New Windsor Business Park
Site Plan - Rt. 300 (Dubin)

SUBJECT: NEW WINDSOR BUSINESS PARK SITE PLAN (LOT 16.8)
IRS SITE - P/B NO. 94-10
FIELD COMPLETION REVIEW 23 JUNE 1995

SUBJECT: NEW WINDSOR BUSINESS PARK SITE PLAN (LOT 16.8)
NEW WINDSOR PLANNING BOARD NO. 94-10
FIELD COMPLETION REVIEW 16 NOVEMBER 1994

PROJECT NAME: NEW WINDSOR BUSINESS PARK SITE PLAN (LOT 16.8)
PROJECT LOCATION: NEW WINDSOR BUSINESS PARK (OFF ROUTE 300)
SECTION 4-BLOCK 2-LOT 16.8
PROJECT NUMBER: 94-10
DATE: 27 APRIL 1994
DESCRIPTION: THE APPLICATION INVOLVES THE CONSTRUCTION OF A
17,640 SQUARE FOOT BUILDING ON THE EXISTING
1.5 +/- ACRE PARCEL WITHIN THE PARK. THE PLAN WAS
PREVIOUSLY REVIEWED AT THE 13 APRIL 1994 PLANNING
BOARD MEETING.

LANDSCAPE PLAN
SCALE: 1"=20'-0"

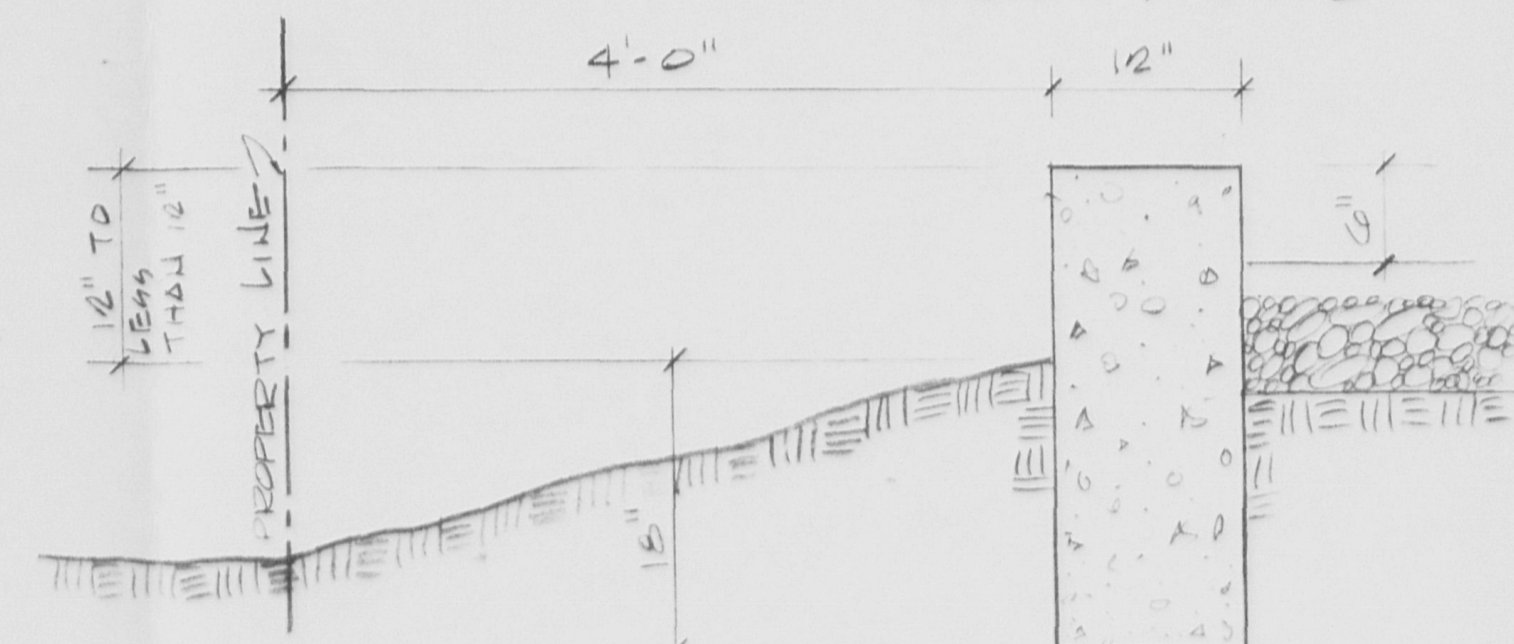
5. All parking space delineation, including the handicapped spaces and signs were not complete.
6. The landscaping as currently installed on the site differs in many areas from the landscape plan approved by the Planning Board. In a few cases, additional or modified landscaping was provided, with the general intent being maintained. In many areas the landscaping is incomplete and significantly deficient from the approved plan. Details are further outlined below.

7. On the left (south) side of the site, the number of Austrian Prines is significantly less than depicted on the approved plan. In addition, the ground surface is unfinished and incomplete.

8. At the rear of the building (west side), all of the red maple plantings depicted have not been installed. In addition, this area is unfinished and incomplete. This area is the area of encroachment onto the Automotive Brake company.

9. On the right side (north side) of the building, all of the red maples shown on the plan have not been installed. In addition, the area is unfinished and incomplete. This area is the encroachment onto the YWCA property.

10. Along the front of the property (east side), only one of the five red maples have been installed. In addition, the ground surface is unfinished and incomplete. This area involves the encroachment onto the Town of New Windsor Town Hall property. Although this encroachment was approved by the Town Supervisor, the work appears incomplete. An acceptable of the work must be received from the Supervisor prior to close-out of this site plan.

8. See comment No. 6 above.
9. See comment No. 6 above.
10. See comment No. 6 above. Also, it is my understanding that the Town has accepted the work along and on the lands of the Town, relative to the boulder and landscaping placed.
11. A flag pole (with flag) has been installed.
12. The paving of Commerce Drive was completed by Town forces as per a previous agreement between the former Supervisor and the Developer.
13. The finish course of the parking lot has been completed.
14. The front gate for the dumpster enclosure has been installed.
15. The drainage on the opposite side of Commerce Drive is part of a subsequent Site Plan application. As such, this will be addressed on that plan.

GRADING/DRAINAGE PLAN

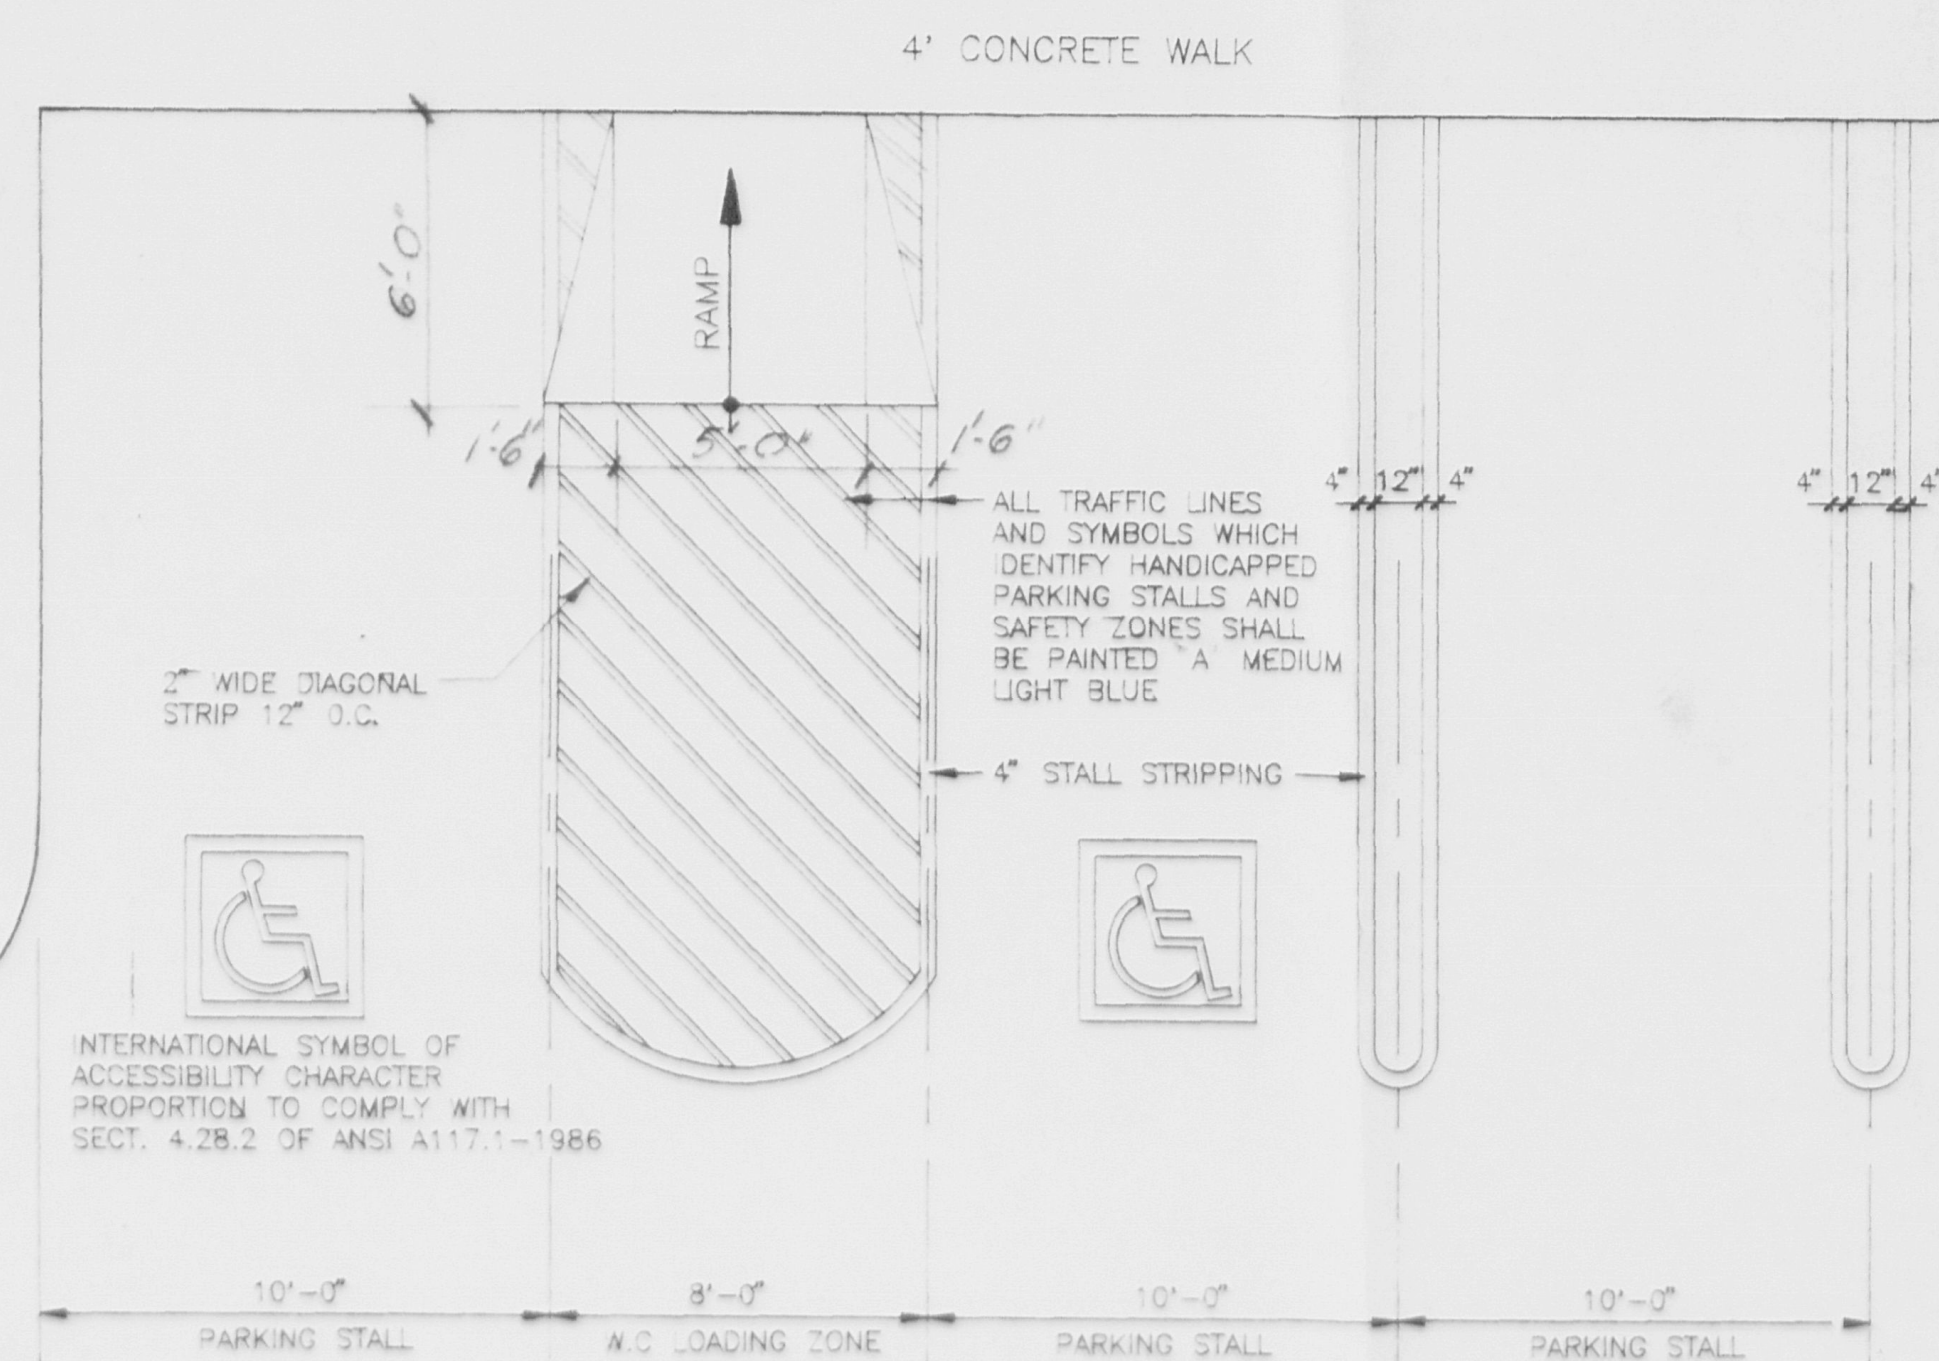
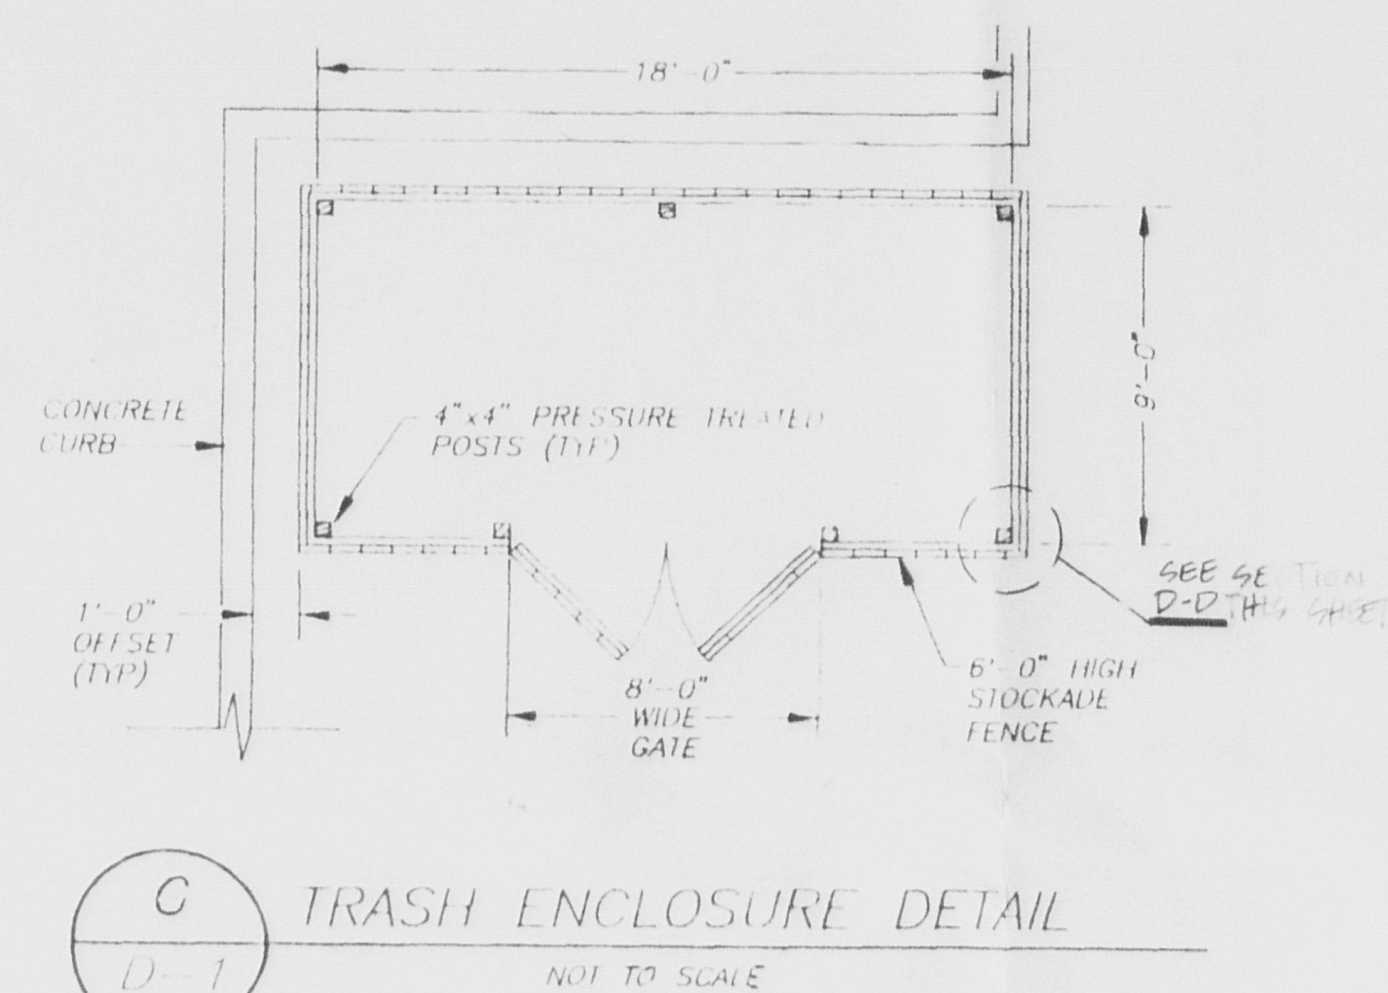
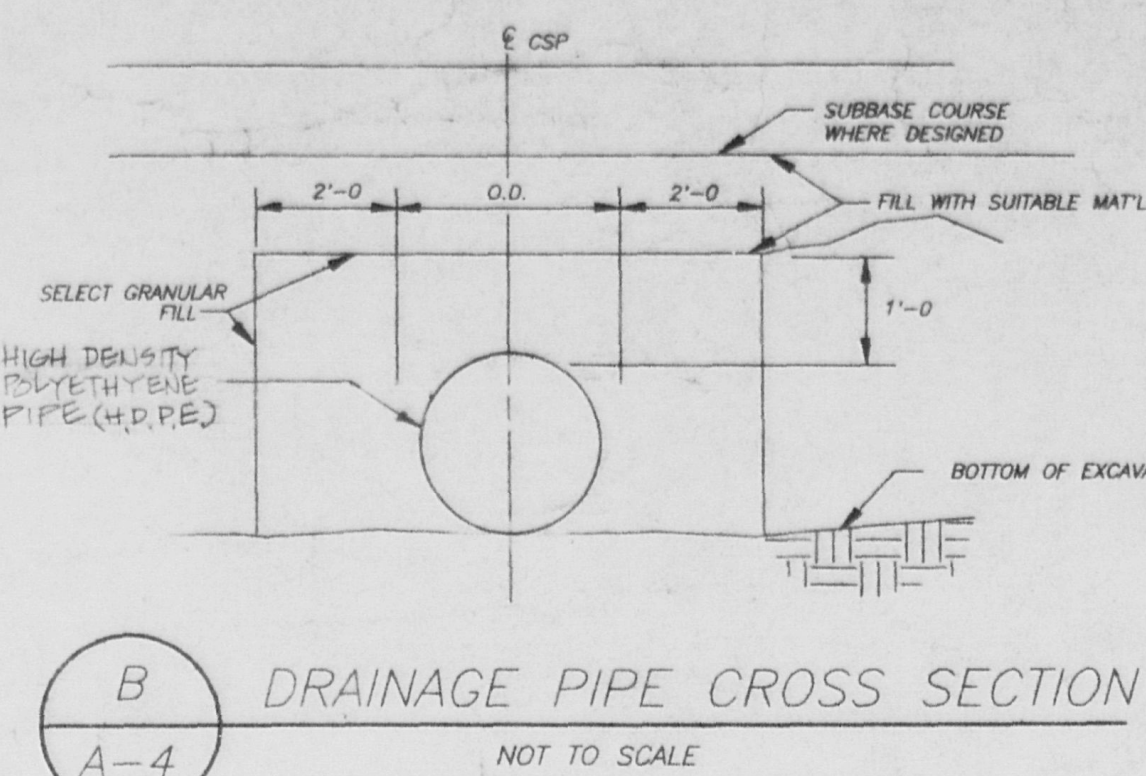
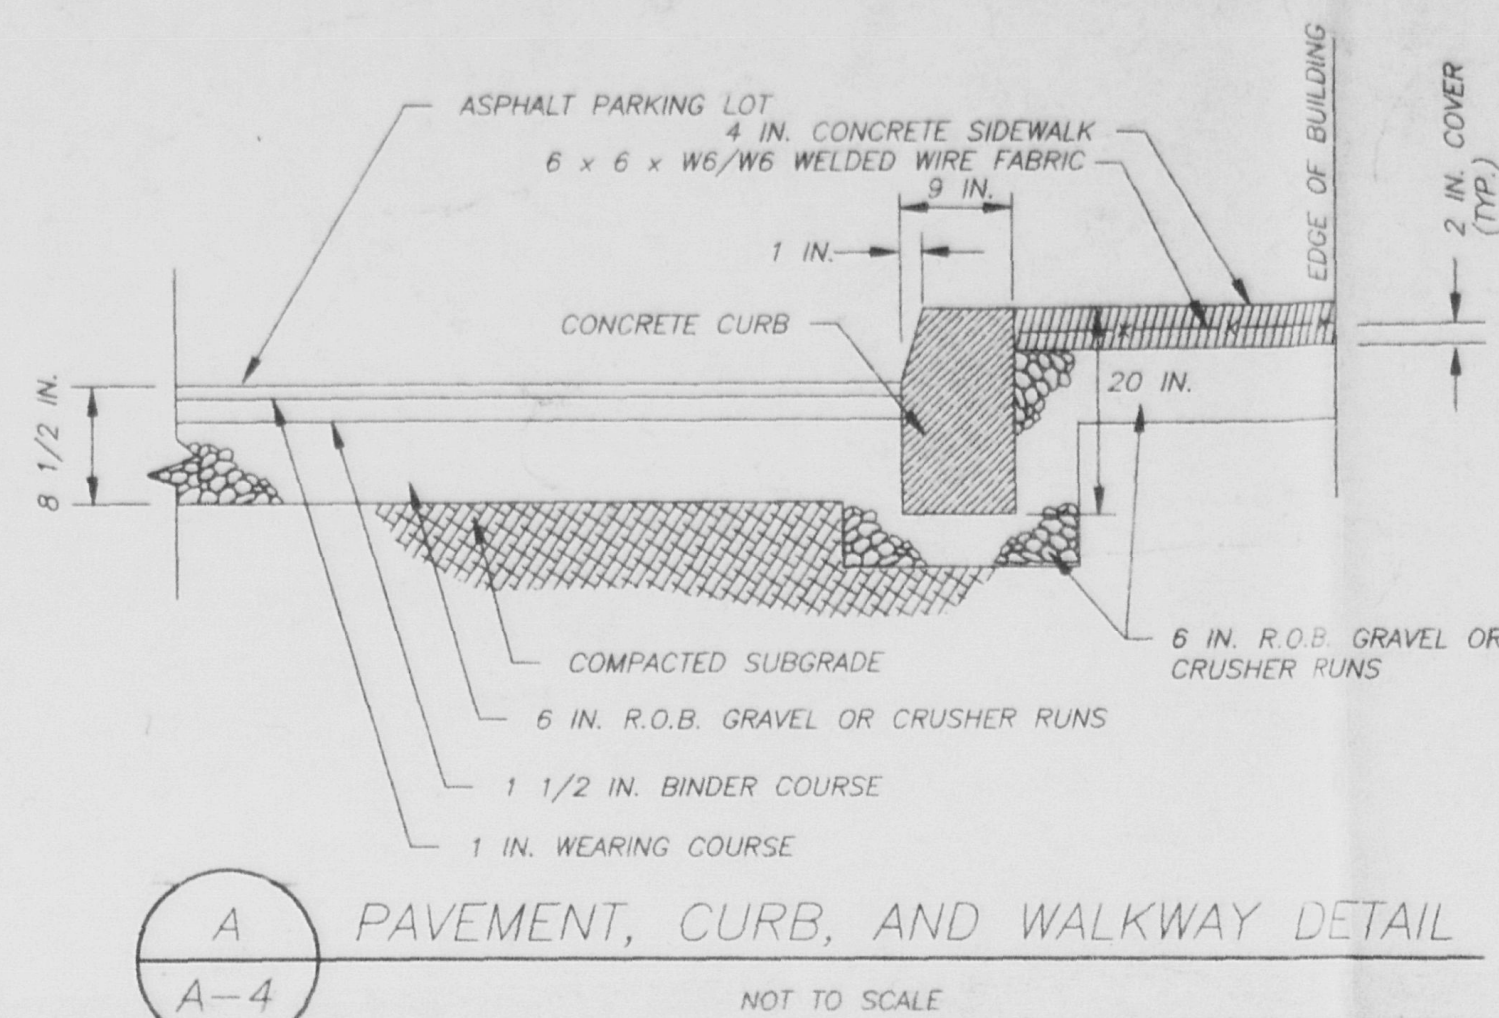
MR. EDSALL: One and 1A do not exist, even though sheet one still says it exists. It doesn't. And the problem I have is that we have to make sure these things work. It's something that can't be left to a field decision because it's been proven in the past that that always doesn't work. And I have no problem with this one because it just so happens I've talked to John about it, this is the highest lot on the site so this one in is the furthest one in to the left, as you come into the commercial drive so there's a very good chance that this one is probably the easiest to develop from a drainage standpoint to get it off the site.

MR. EDSALL: There's no open swale in existence. In fact, the discharge line shown on the plan is three foot below the ground so again, we have to get it from point A to point B in an acceptable manner based on the proper storm incident and ensure that there's not backups or property damage, that is my only comment.

- a. It should be acknowledged that site grading on the adjoining New Windsor Business Park site will be required.
- b. The indicated rim elevation for Catch Basin 2 is in error and should be corrected. All rim elevations for the drainage system should be double-checked.
- c. The plan indicates Catch Basin 1 and the outlet pipe as existing. Apparently, these were never constructed and, in fact, do not exist as indicated on the plan. Inasmuch as the invert elevation is over 3' below finished grade, an outlet location must be indicated. Proper ability to discharge drainage so as not to cause other problems, must be a part of this site design.

- e. A note should be added to the plan indicating that additional versa block wall and/or curb wall should be installed, as necessary, based on the final construction conditions encountered on the site. It is my belief that additional such walls will be required along the north and west property lines, given the grades shown.

- d. The plans indicate 1% slope for all collection piping on the site. Either this value is incorrect or the invert elevations are incorrect, since the calculated slopes (based on the inverts) do not agree.

- e. The rim elevations of the catch basins must be coordinated with the proposed contours on the plan. In one location, there appears to be a 2 foot error between the catch basin rim elevation and the elevation information based on proposed contours. All catch basin rim elevations should be coordinated with proposed grades.

- f. The plan indicates 12 inch stormwater piping for the westerly collection branch. It is my opinion that all piping on commercial sites should be minimum 15 inch diameter. If 12 inch piping is permitted, adequate capacity should be verified, especially given the extremely "flat" slopes which may exist.
